Access Assessment Report

84 Cambewarra Road, Bomaderry

Reference No: 114572-Access-r02.1

Client: Shoalhaven City Council

Figure: Principal Pedestrian entry to be accessible.

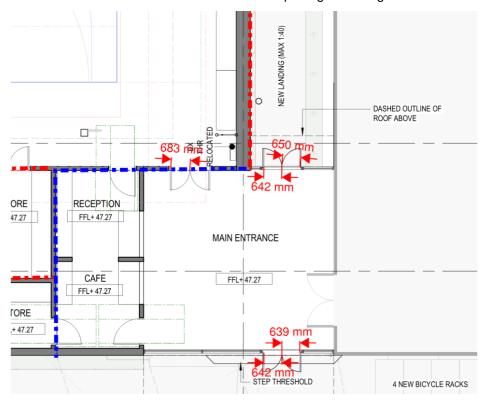
The two entry points to the building are required to be accessible whereby they are located greater than 50m apart. This will require compliant door hardware and/or push-button access in accordance with Clause D2.21 and AS1428.1-2009 and a minimum clear door leaf opening achieving 850mm.

Figure: Stair in accessway linking courts 5 & 6 to incorporate accessible features.

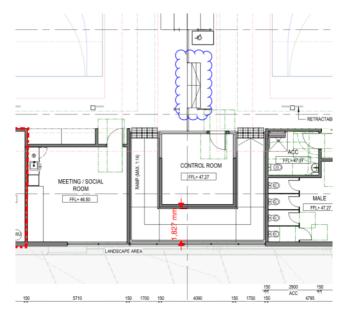
All accessible stairways are to incorporate the following accessible features:

Stair Provisions - Each access stair shall incorporate the following design provisions:

- (a) Tactile Ground Surface Indicators (TGSI's) are to be provided at the landings to every stair. TGSI are to comply with BCA D3.8 and AS1428.4.1-2009 requirements; and
- (b) Handrail provisions complying with Clauses BCA D3.3, and 11 & 12 of AS1428.1-2009; and
- (c) Non-slip nosing strips with appropriate luminance contrast in accordance with BCA D2.14 and AS1428.1-2009; and
- (d) Opaque (solid) risers.
